SUBJECT: COMANCHE PEAK STEAM ELECTRIC STATION (CPSES)  
DOCKET NOS. 50-445 AND 50-446  
ADVANCE COPY OF FSAR REVISIONS RELATING TO JET IMPINGEMENT

By letter dated March 28, 1988, we committed to provide the NRC with an advance copy of revisions to FSAR Section 3.6B incorporating ANSI/ANS Standard 58.2 Working Draft 7, dated August 1987, as the basis for jet impingement analyses.

Attachment 1 is an advance copy of these revisions with locations of the specific changes indicated by revision bars in the margin.

Attachment 2 provides an item by item description of each change.

COMANCHE PEAK S.E.S. FINAL SAFETY ANALYSIS REPORT UNITS 1 & 2
CIRCUMFERENTIAL PIPE BREAK WITH FULL SEPARATION JET CONE
FIGURE 3.6B-96A

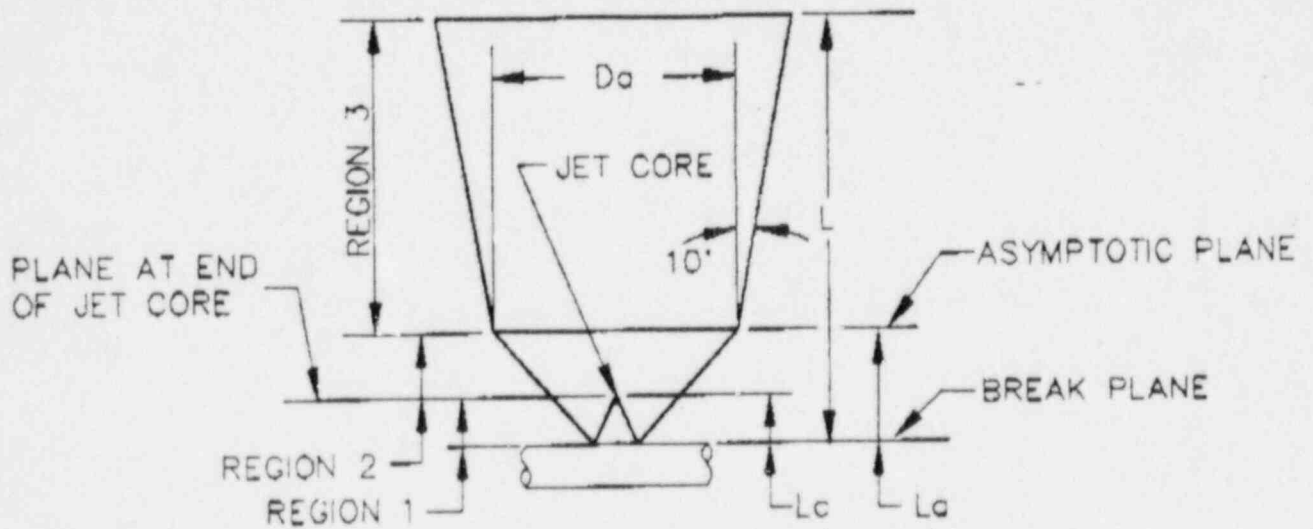
Figure Addition: Provides a new figure to illustrate the three region jet  
3.6B-96A cone model for determination of jet impingement affects of a  
circumferential break with full separation. This figure is used in  
conjunction with the ANSI/ANS 58.2 primary methodology. Also see  
description at 3.6B-33 thru 3.6B-44.  
(88-438)

Category III jets are assumed to expand as a three region cone defined in Figure 3.6B - 96A for circumferential breaks and Figure 3.6B - 96B for longitudinal breaks [22]. | ADVANCE

FIGURE 3.6B-96B

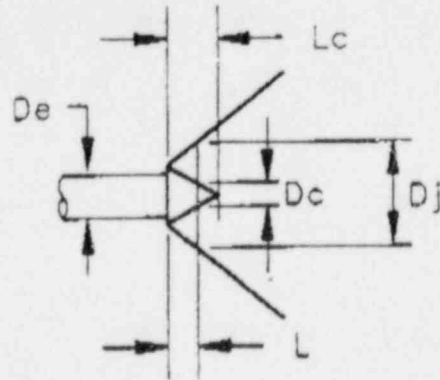
- Figure 3.6B-96B Addition: Provides a new figure to illustrate the three region jet cone model for determination of jet impingement affects of a longitudinal break. This figure is used in conjunction with the ANSI/ANS 58.2 primary methodology. See description at 3.6B-33 thru 3.6B-44. (88-438)

The jet shape for longitudinal breaks, as shown in Figure 3.6B-96B shall be assumed to be the same as the circumferential break defined in a.3.1. A jet diameter for a circular break of the same area may be used and the jet direction taken to be perpendicular to the axis of the pipe.

FIGURE 3.6B-96C

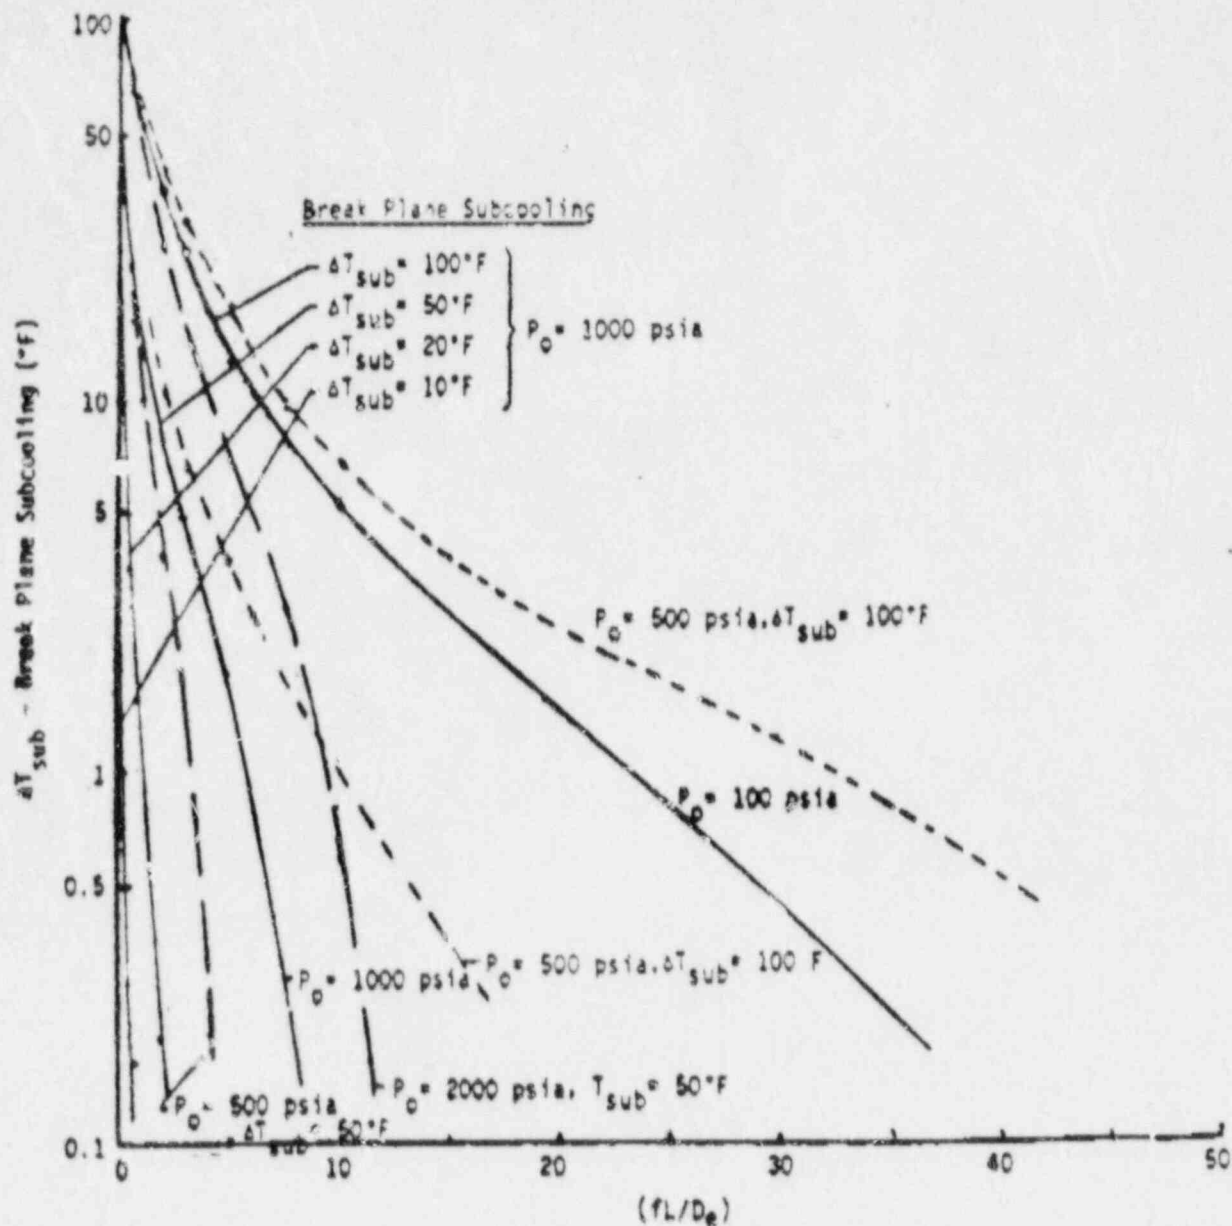
- Figure 3.6B-96C Addition: Provides a new figure to illustrate the jet cone geometry for a circumferential break with full separation. This figure is used in conjunction with the ANSI/ANS 58.2 primary methodology. Also see description at 3.6B-33 thru 3.6B-44. (88-438)

Jet Region 1 ( $L < L_c$ ). Region 1 includes a cone-shaped region containing the jet core and the remainder of the jet. This geometry is shown in Figure 3.6B-96C. | ADVANCE

FIGURE 3.6B-96D

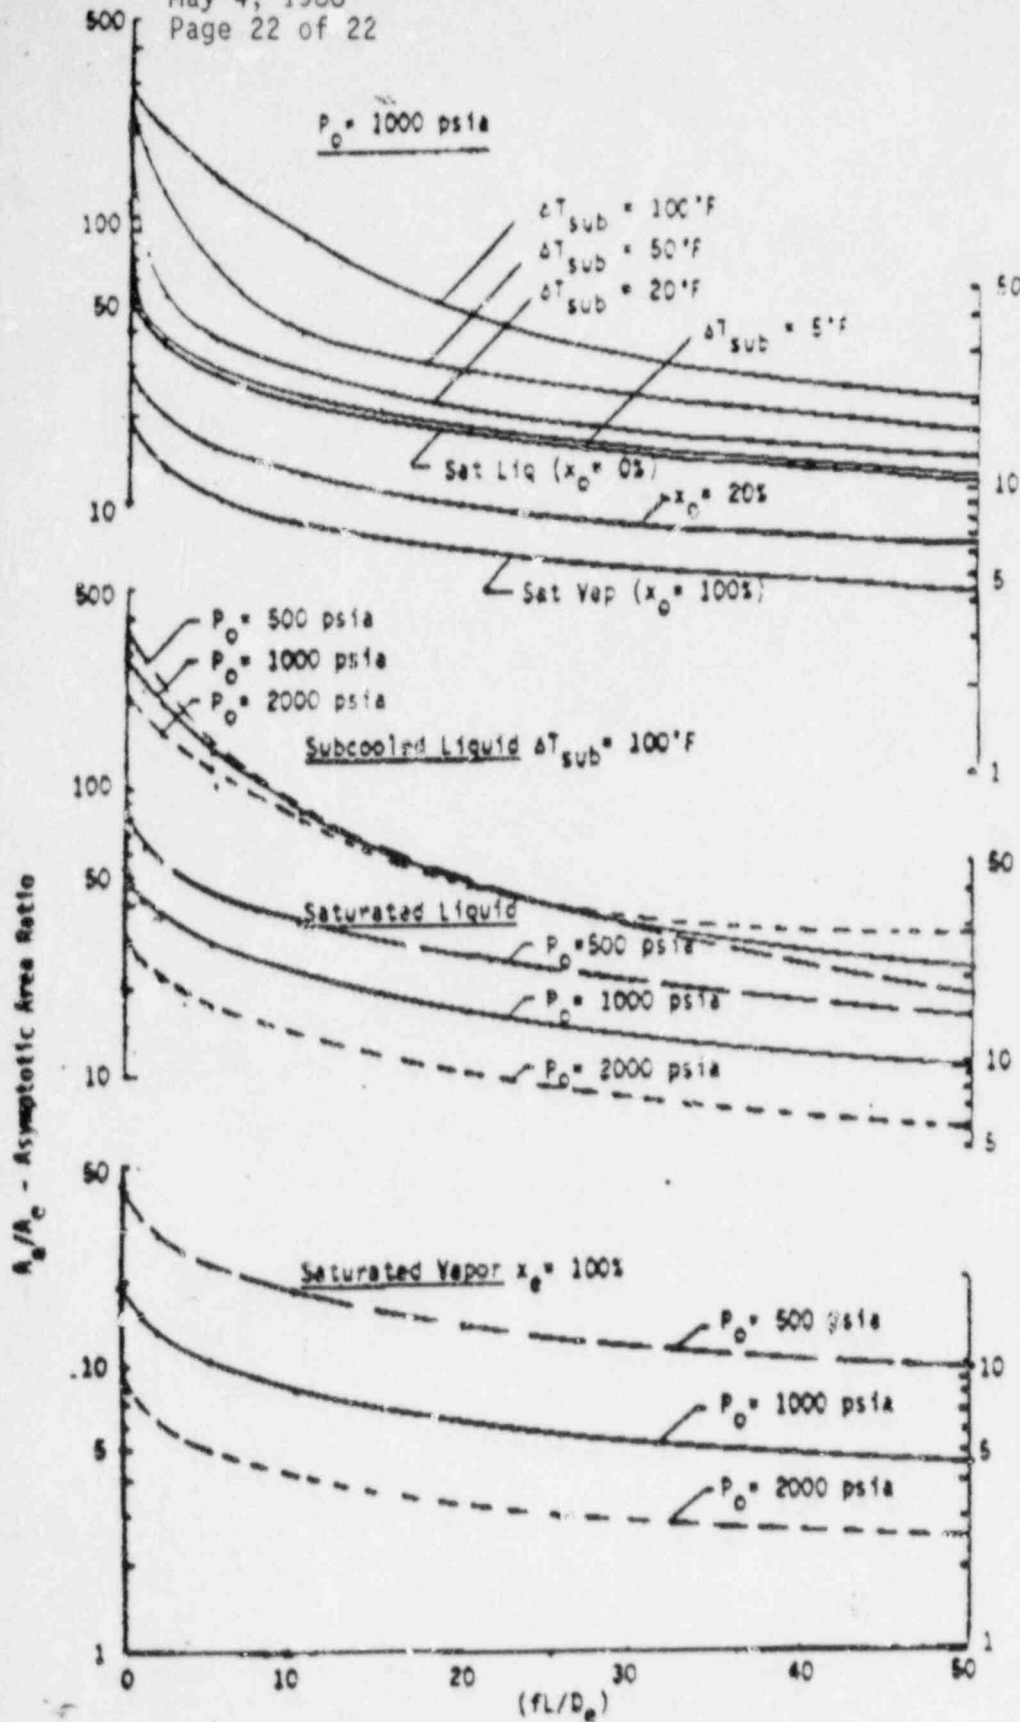
- Figure 3.6B-96D Addition: Provides a new figure which can be utilized to relate stagnation subcooling at the break plane to stagnation conditions in the vessel supplying the jet flow, accounting for irreversible losses in the blowdown line. This figure is used in conjunction with the ANSI/ANS 58.2 primary methodology. (88-438)

Figure 3.6B-96D can be used to relate jet stagnation subcooling at the break plane to stagnation conditions in the vessel supplying the jet flow, accounting for irreversible losses in the blowdown line. | ADVANCE
